Department of Toxic Substances Control

August 07, 2015

The Department of Toxic Substances Control (DTSC) received the *Draft Phase IV Sampling Results Technical Memorandum* (Memorandum), dated June 5, 2015, for the Richmond Field Station Site, Berkeley Global Campus at Richmond Bay, located in Richmond, California. The Memorandum was prepared by Tetra Tech, Inc. on behalf of the University of California, Berkeley.

SUBJECT: Phase IV Sampling Results Technical Memorandum
RICHMOND FIELD STATION SITE, UNIVERSITY OF CALIFORNIA,
BERKELEY
PCA 11018 Site Code: 201605-00

FIGURE 13
PROPOSED
SOIL SAMPLING LOCATIONS
EPA NORTH MEADOW

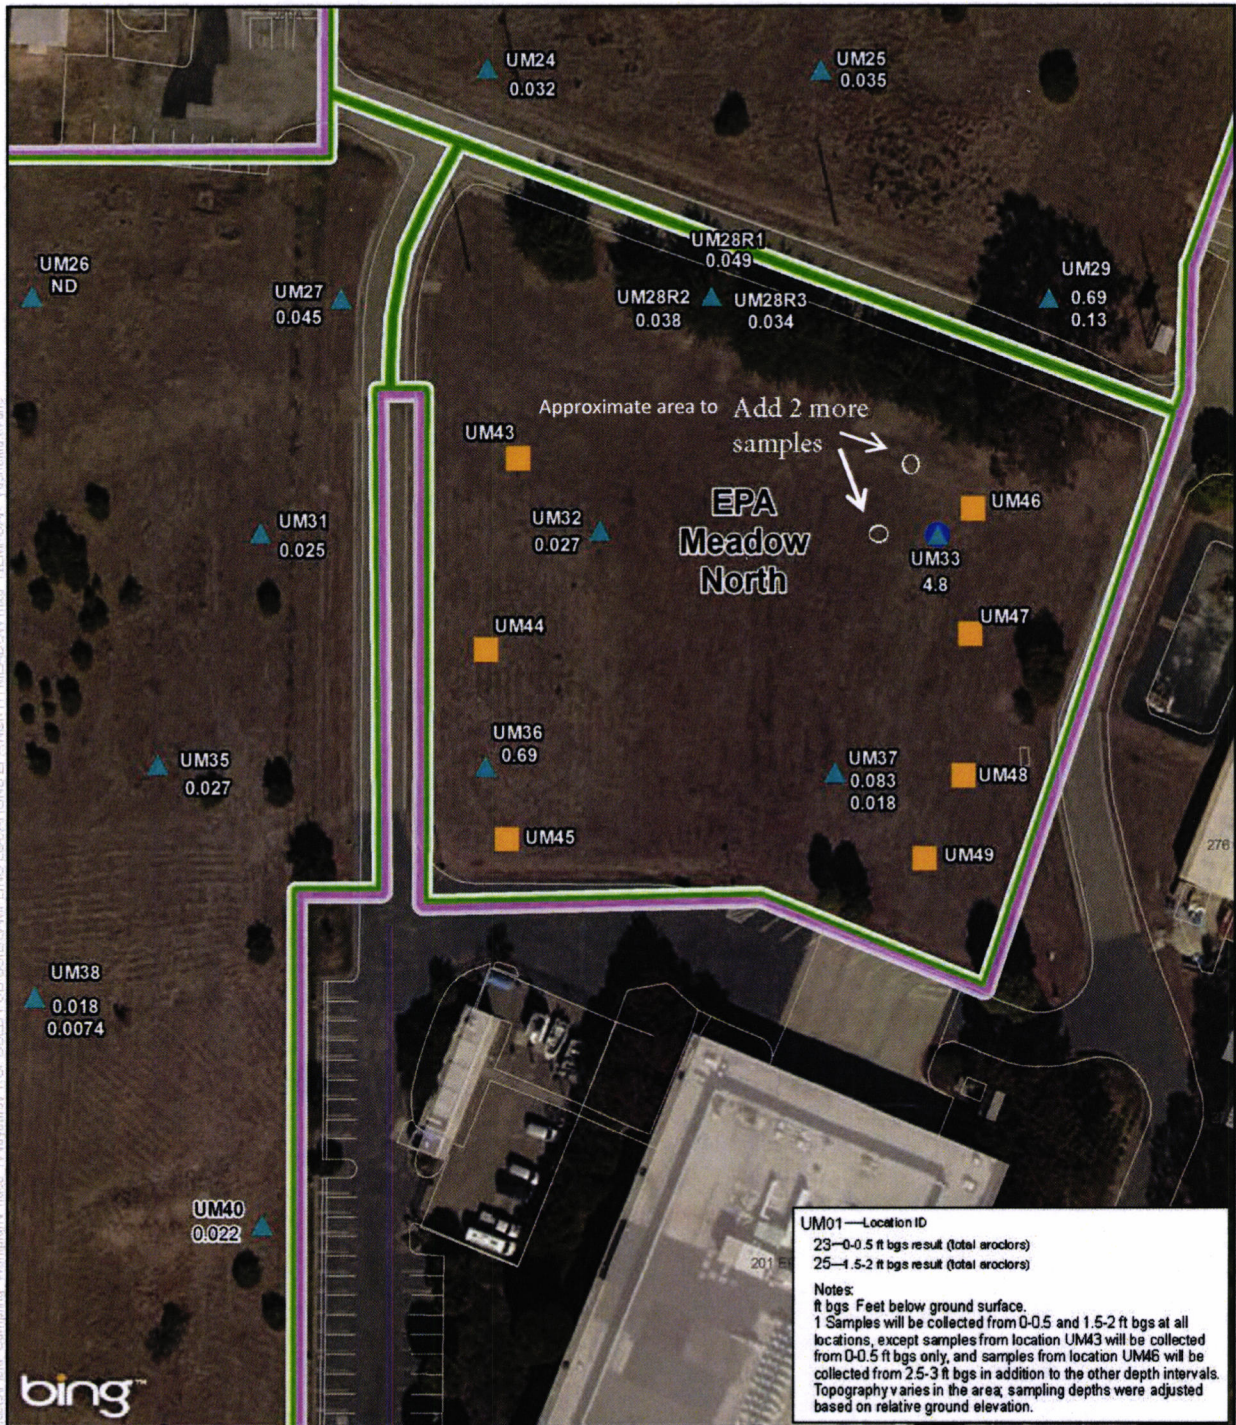
7. Figures 9, 10 and 11: The figures contain symbols and numerical values not identified or explained in the explanation. Revise the explanation.
8. Figure 13: Include two additional sample points around location UM33 as identified on the enclosed figure to determine if any sediment transport has occurred away from the raised area.

Your proposal to collect additional soil samples in the Upland Meadows for PCBs is approved with the addition of the two sample locations identified in the enclosure. Please provide DTSC with at least three weeks notice of the sampling event so that we may prepare and distribute a work notice. In addition, provide a response to these comments within 30 days of the date of this letter.
